Product Change Notification (PCN)

- Profinet Cable
- no impact to fit, form or function

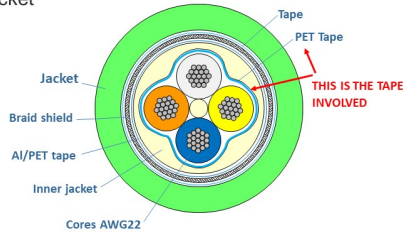
- Before the change. Tape present between assembly and inner jacket

- After removal of PET tape over assembly, between cores and inner jacket.
